KMR.CDD.LyQ.1918.01

In reply to their letter dated the 26th October 1918,
Messrs Nadirshah & Co., are informed that on reconsideration the
Collector is pleased to sanction the erection of stables by their
client on plot No. 59 sheet K-5, Lyari Quarter.

Re plans of proposed stable on plot no 59, K-5

PLAN SHOWING PROPOSED STABLES TO BE BUILT ON

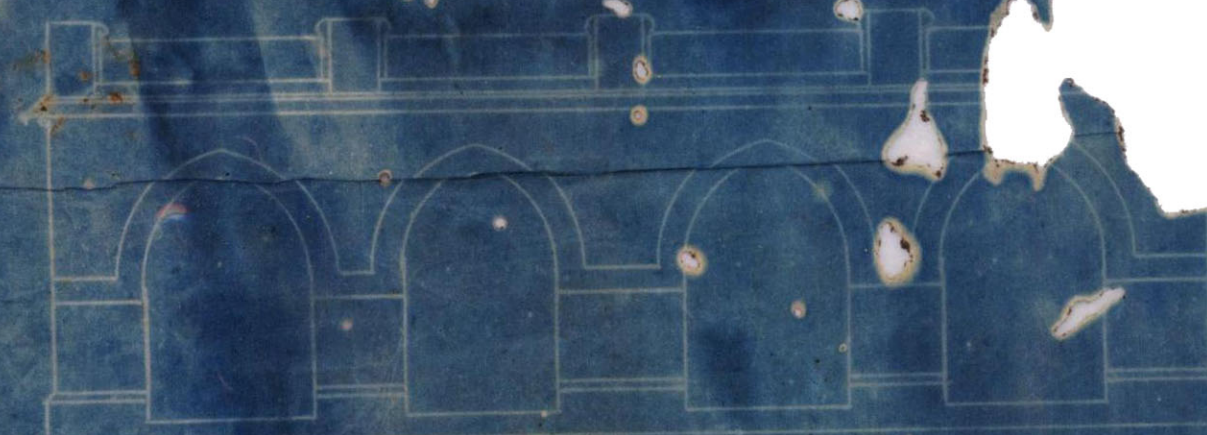
With reference to his application dated 26th April 1918 with plans for the stables to be erected on plot No.59,K-5, Lyari Quarter, Mr Shewaram Nandiram is informed that the plan is very badly designed. The Centre wall must be entirely removed and the space left open to sky with proper provision for light and air to the stables. At least one room must be provided for a chowkidar. The plan is herewith returned dis approved.

*The stables are not well ventilated.
The applicant must clear the
central well & leave the entire
space open to sky.*

I beg to report that if the central wall of stone
 is removed the whole space left open
 to sky then there appear no objection.

The plan is very badly designed.
 The central wall must be entirely
 removed & the space left open to
 sky with proper provision for light
 & air to the stables. At least one
 room must be provided for the stableman.

~~With~~ In compliance with your memo no 4308 dated $\frac{13}{15}$ th Ultimo I have the honour to resubmit the set of plans for the proposed stable to be built on plot no 59 sheet K-5 Lyari 62. The centre wall as suggested in your memo no 4308 has been removed providing an opening 6'0" wide to all the stables. One room for a chowkidar has been provided in the plans. Now you will be pleased to approve & return my plans as early as possible.
